HYUNDAI Technical Service Bulletin

GROUP	NUMBER
BODY ELECTRICAL	22-BE-007H
DATE	MODEL(S)
OCTOBER, 2022	Accent (HC)

SUBJECT: HORN RELAY AND CLOCK SPRING REPLACEMENT

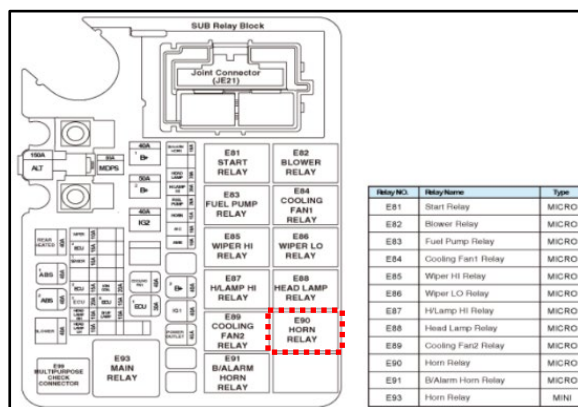
2. Locate the relay box located on the Engine Room Junction Block.

3. Replace “E90 Horn” relay located on the fuse box and take note of the LOT number of the relay and mention on the verbatim.

STUI

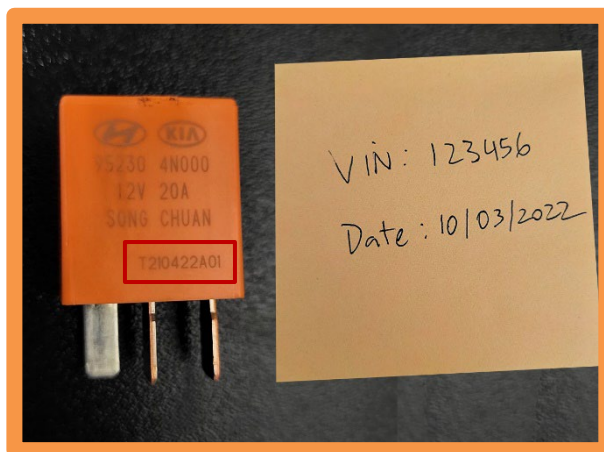
Using STUI, take a photo of the relay with the last 6 digits of the VIN and the date of repair on a piece of paper.

Upload the photo to STUI.
